Delegated officer report for planning application

Application no. 144080/FO/2025

Proposal: Installation of 13 vehicle charging stations, including the installation of a feeder pillar, a substation and underground cabling

Address: Parrs Wood, Manchester, M20 5PG

Submitted proposed elevations of substation, feeder pillar, and chargers

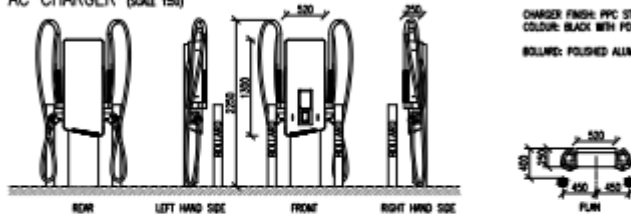
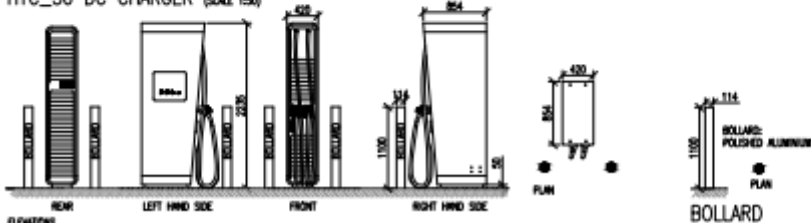
- *2no. bollards are to be provided at each charger - Will this affect access particularly in terms of door clearance when vehicles are parked?
- *It would be useful to understand the frequency of maintenance and vehicle type associated with the proposed substation.

5no. AC chargers are proposed. The AC charger measures to 0.25m in width, 0.26m in depth, and 1.44m in height. Two bollards (measuring to 0.11m in width and 0.9m in height) will be provided at each charger. 5no. signage poles are also proposed to indicate that these bays are for electric vehicle charging only. The proposed signage is small in nature, erected on a 1m high bollard.

6no. HYC150 DC chargers are proposed. The HYC150 DC charger measures to 0.42m in width, 0.85m in depth, and 2.24m in height. Two bollards (measuring to 0.11m in width and 1.1m in height) will also be provided on either side of each charger.

2no. HYC50 DC chargers are proposed. The HYC50 DC charger measures to 0.52m in width, 0.4m in depth and 2.25m in height. Two bollards (measuring to 0.11m in width and 1.1m in height) will also be provided on either side of each charger.

A substation is also proposed. The proposed substation measures to 3m in width, 3m in depth and 2.4m in height and will be manufactured from GRP (glass reinforced plastic), finished in the colour green.

In addition to this, a feeder pillar is also proposed. The proposed feeder pillar will measure to approximately 2m in width, 0.55m in depth and 1.8m in height and will be manufactured in GRP (glass reinforced plastic), finished in the colour green.

Submitted existing and proposed plans of vehicle charging stations

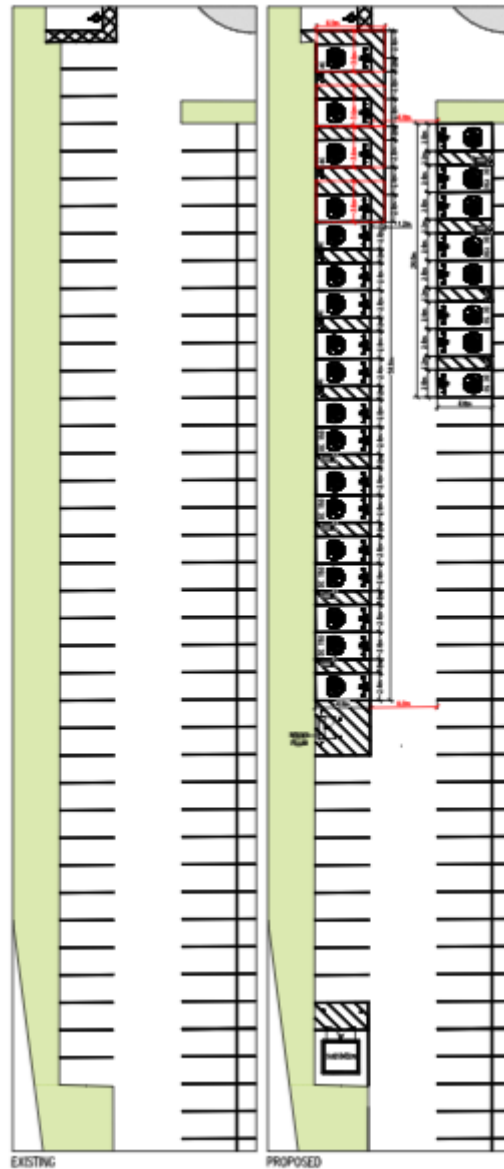
- It is proposed that 26no. EV charging bays including 4no. disabled bays are to be provided at the car park. *Noted that there will be a loss of 10no. car parking bays – Does this include the bays removed to accommodate the proposed substation?

- *Further Information is required regarding the total number of car parking spaces provided at the car park serving the Leisure Complex.
- Plans indicate that the dimensions of standard EV charging bays are 2.4m x 4.8m. This is in line with MCC requirements.

- *Disabled parking bay dimensions should be a minimum of 3.6m x 6.0m - Confirmation is required and should be clearly demonstrated on an updated plan.

- A minimum 6-metre aisle width should be provided to allow vehicles to safely manoeuvre within the car park.
- *Clarification is sought on the retained aisle width between the proposed EV charging bays, standard parking bays and the substation. This should be illustrated on an updated plan with dimensions included.

- Highways recommend that the EV charging points have minimum charging unit of 7kW.
- *In situations where the car park is operating near full capacity and non-EV occupy EV bays how will this be managed?

- *Signage poles are proposed to indicate that the bays are for EV charging only - Clarification is required on the location of the poles and should be shown on an updated dimensioned plan.

- *Proposed Plans indicate that the doors to the feeder pillar open outwards affecting access to the proposed EV charging bay.
- Access to the car park should be maintained during any construction works associated with the development.

Parking and highways impact – MCC Highways Services have reviewed the proposal and confirmed that the leisure complex is currently served by approximately 774 car parking spaces. The development would result in the loss of 12 spaces to accommodate 13 EV charging stations, one feeder pillar, and one substation. This level of reduction has been assessed as acceptable.

The submitted plans indicate that the dimensions of the proposed disabled EV charging bays are 3.6m x 6.0m, which accords with MCC standards. A 6m aisle width will be retained within

the car park, ensuring adequate manoeuvrability. Each EV charger will provide a charging capacity of 22kW, split between two bays. The proposed signage poles are shown on the plans and do not appear to impede access to or from the EV bays.

It is understood that maintenance visits to the substation will be infrequent. The plans also show that the doors to the feeder pillar open outwards; therefore, appropriate management measures should be in place during any maintenance activities to ensure safety and avoid obstruction within the car park.
